City of Scotts Valley
PLANNING COMMISSION
STAFF REPORT

Date: November 17, 2016

Mitigated Negative Declaration	MND15-002
General Plan Amendment	GPA15-003
Zone Change	ZC15-003
Planned Development	PD15-002
Land Division	LD15-002
Design Review	DR15-004

Location: Dunslee Way (no address as a vacant lot) / APN: 022-451-01

1 MASTER SITE PLAN
Scale: 1" = 20'-0"

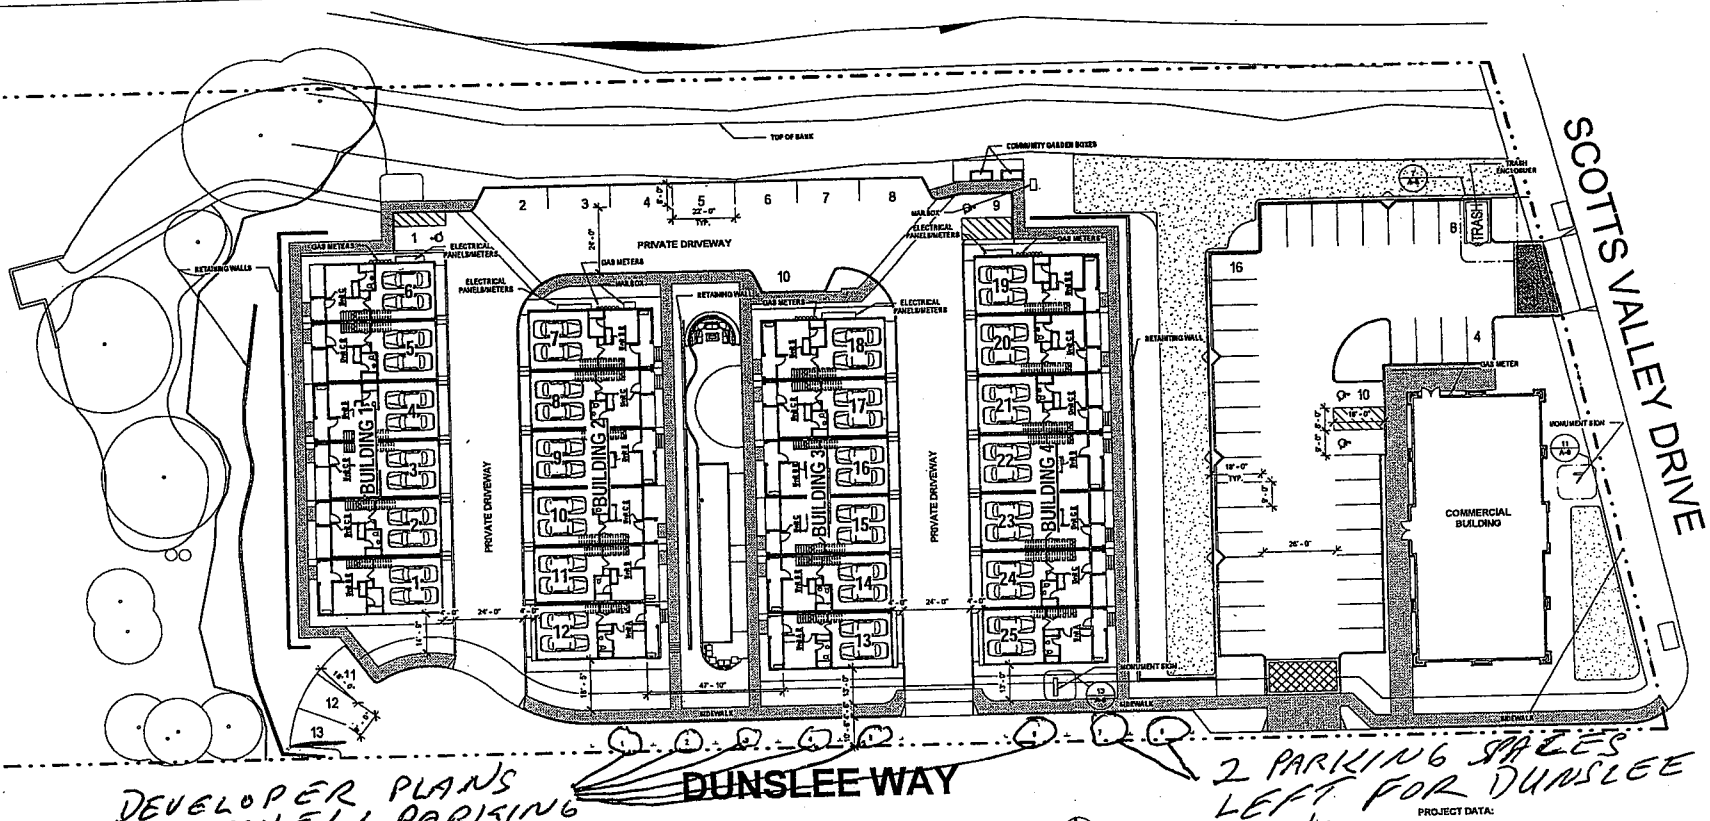
B. There are 19 guest parking spaces of which only 13 spaces are on the developer's property. The remaining six parking places as proposed by the developer appeared to be taken from the residents of Dunslee Way. According to the site plan, (see attachment A-1) the developer is planning on using six of the eight parking spaces that would be created by the road widening. As Dunslee Way exists now, the existing residents can park twelve cars on Dunslee Way. After widening, the residents will only have two parking spaces. (Eight spaces created - six spaces are allocated for the development = two spaces remaining). So the residents will actually lose ten parking spaces! This street has already experienced disputes over parking that required calling the Scotts Valley Police to intervene. You can bet that the eight spaces on Dunslee Way will be in hot demand, "first come, first served" and that fights over "my spot" will occur.

Solution: I request that the developer provide 4 parking spaces per unit on his own property!

DEVELOPER PLANS TO TAKE! 6 PARKING SPACES

2 PARKING SPACES LEFT FOR DUNSLEE WAY!

- On-site Guest Parking: The proposed project will provide 19 on-site surface parking spaces: 3 at the end of the cul-de-sac and 16 along the north property line, as shown on the provided Sheet TM-04. The proposed 19 spaces exceed the minimum required of 5 spaces. Via a parking easement, the developer proposes to allow project residents to park in the commercial parking lot. City Departments believe that the proposed amount of parking should be adequate. The Planning Commission will review the proposal and make a recommendation to the City Council who will take final action at a future public hearing to be scheduled.

- Street Parking: The proposed project will provide 8 parallel parking spaces on Dunslee Way that will be available to the public and are not considered as project parking.
